Delegated Report		Analysis sheet	Expiry Date:	09/03/2021
		N/A / attached	Consultation Expiry Date:	07/03/2021
Officer			Application Number(s)	
Raymond Yeung			2021/0124/P	
Application Address			Drawing Numbers	
5 Mornington Place London NW1 7RP			Please see decision.	
PO 3/4	Area Team Signature	C&UD	Authorised Officer Signature	
Proposal(s)				
Erection of a Mansard roof extension.				
Recommendation(s):		Grant Conditional Planning Permission		
Application Type:		Full Planning Permission

1 PROPOSAL

Figure 1. The terrace at 3-7 Mornington Place

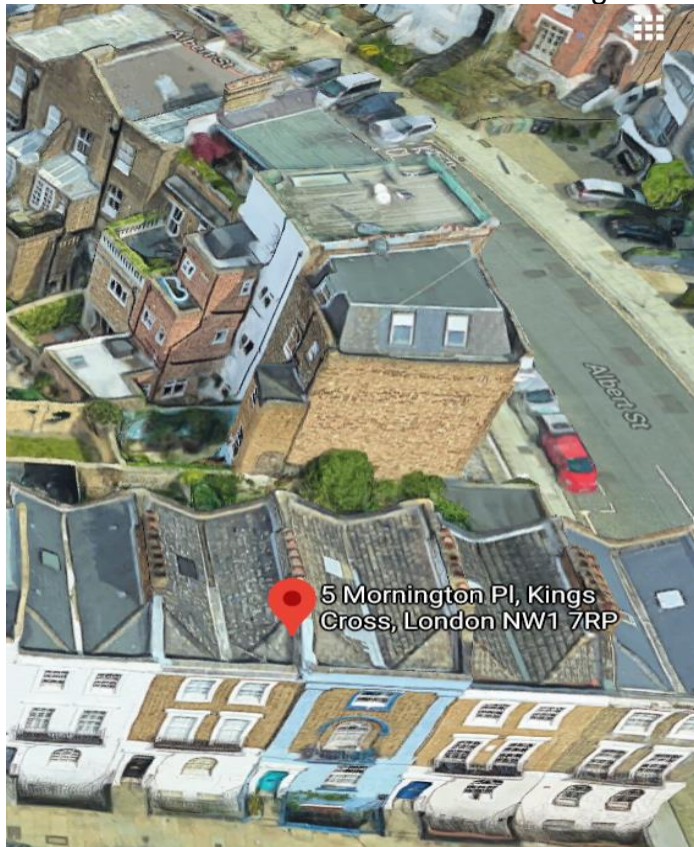
2.2.8 It is noted that this particular terrace has an unbroken roof line in that there are no roof additions in this short terrace.

2.2.9 The Council's policy takes a flexible approach to roof extensions. However, in this case, the unbroken roofline is considered to be of significant heritage value.

2.2.9 It is noted that No.5 is designed in a unique way and has a central focus within the terrace. Therefore, consideration for proposals on this particular property shall be considered with additional sympathy as any extensions on the roof would appear incongruous and prominent and would not be sympathetic to the special design of this property.

2.2.11 On an unbroken uniform roofline of the terrace, the proposal would add an additional 3.1m height, 6.9m depth and 5.1m at full width, this is considered to add unacceptable bulk and appear incongruous to the terrace.

2.2.16 The proposed mansard roof extension by reason of their location, scale, height and detailed design, would result in a incongruous and bulky addition that would be detrimental to the character and appearance of the host building, the terrace of adjoining buildings, the streetscene and the Camden Town Conservation Area, contrary to policies D1 (Design) and D2 (Heritage) of the London Borough of Camden Local Plan 2017.

3.1 Refuse planning permission
